DART AEROSPACE LTD	Work Order: 137020
Description: Crosstube Assembly (206L High Fwd)	Part Number: D206-667-143
Inspection Dwg: D206-667-143 Rev: C	Page 1 of 2

DRAWING NO. D206-667-143	TITLE CROSSTUBE ASS'Y (206L HIGH FWD)	REV. C	DART AEROSPACE LTD ENGINEERING ORDER		D.E.O. NO. D206-667-143-C-1	SHEET NO. SHEET 1 OF 1	SCALE NTS
DRAWN <i>q</i>	CHECKED <i>ASS</i>	MFG. APPR. <i>12</i>	APPROVED <i>MD</i>		DE APPR. <i>11</i>		
DATE 11.07.15	DATE 11.07.20	DATE 11.07.21	DATE 11/07/21		DATE 11.07.21

DRAWING NO. D206-667-143		TITLE CROSSTUBE ASS'Y (206L HIGH FWD)		REV. C	DART AEROSPACE LTD ENGINEERING ORDER		D.E.O. NO. D206-667-143-C-2	SHEET NO. SHEET 1 OF 1	SCALE NTS
DRAWN AJS		CHECKED [Signature]		MFG. APPR. [Signature]		APPROVED [Signature]		DE APPR. [Signature]	
DATE 12.08.02		DATE 12.08.02		DATE 12.08.02		DATE 12.08.02		DATE 12-08-02

DETAIL P
BONDING STRAP INSTALLATION 2 PL

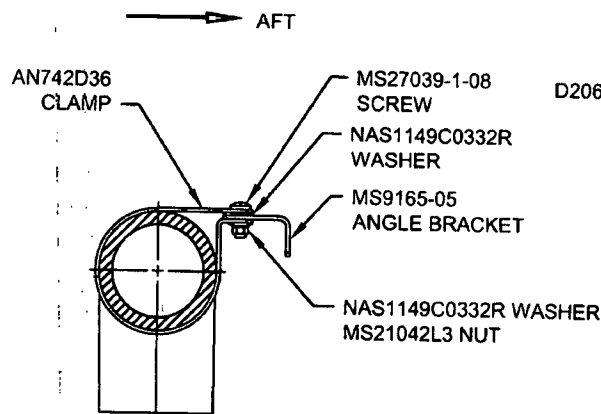
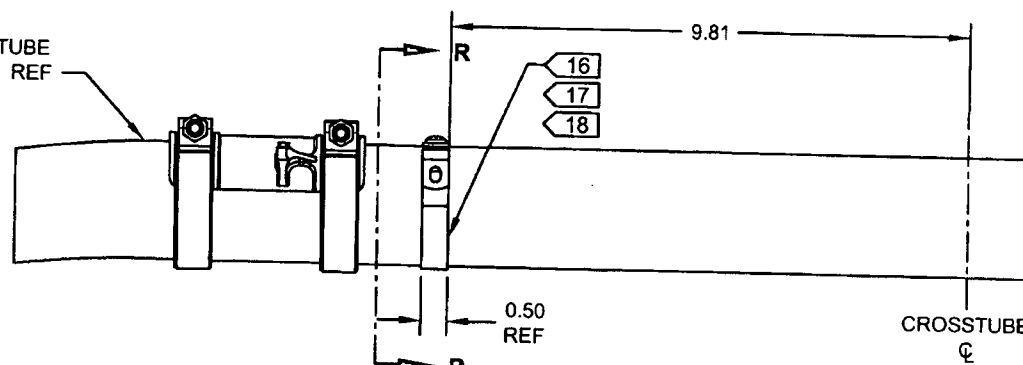
PURPOSE:

ADD ELECTRICAL GROUNDING STRAP

ADD

- 16) MASK AREA UNDER CLAMP PRIOR TO PAINTING
- 17) SEAL EDGES WHERE AN742D36 CLAMP MEETS WITH THE CROSSTUBE USING SIKAFLEX-241/-291 OR MIL-S-8802 CLASS B2 OR PROSEAL 890 SEALANT
- 18) PERFORM RESISTANCE CHECK TO ENSURE MAX RESISTANCE IS 10 MILLIOHMS

ITEM	QTY -143	PART NUMBER	DESCRIPTION
1	X	D206-667-143	CROSSTUBE ASSEMBLY (206L HIGH FWD)
⚡			
10	2	AN742D36	CLAMP
11	2	MS9165-05	ANGLE BRACKET
12	2	MS21042L3	NUT (OR MS21042-3)
13	2	MS27039-1-08	SCREW
14	4	NAS1149C0332R	WASHER (OR AN960C10L)
